COUNTY COUNCIL

Re: Draft TER open question concerning subsidence

COMBINED STRUCTURAL
MODEL FOR THE SITE

Figure
2-18

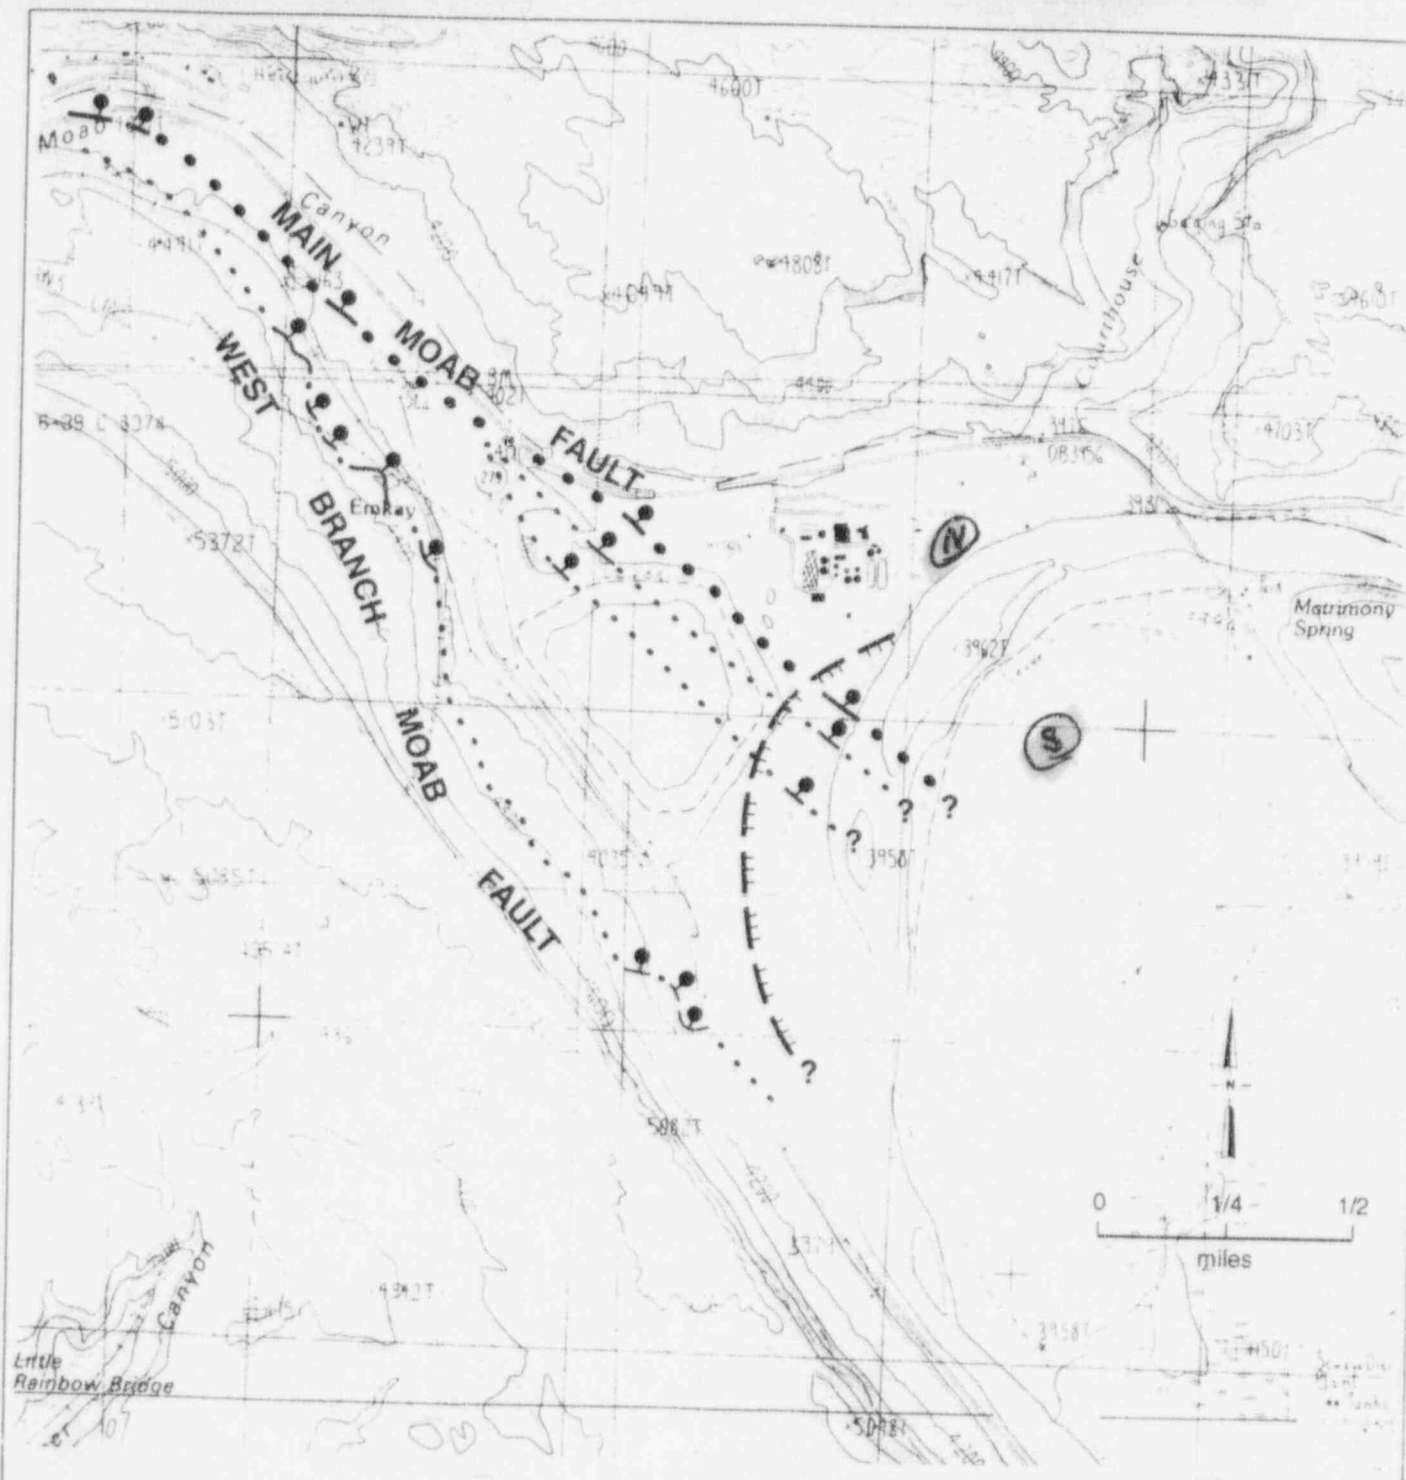
Also, within the document titled: "Evaluation of Potential Seismic and Salt Dissolution Hazards at the Atlas Uranium Mill Tailings Site, Moab, Utah" by Woodward-Clyde there is Section 3.0: Potential for Salt-Dissolution Collapse. The contents of Section 3.0 were to be submitted later. Have the contents been submitted and if so could we please receive a copy of them?
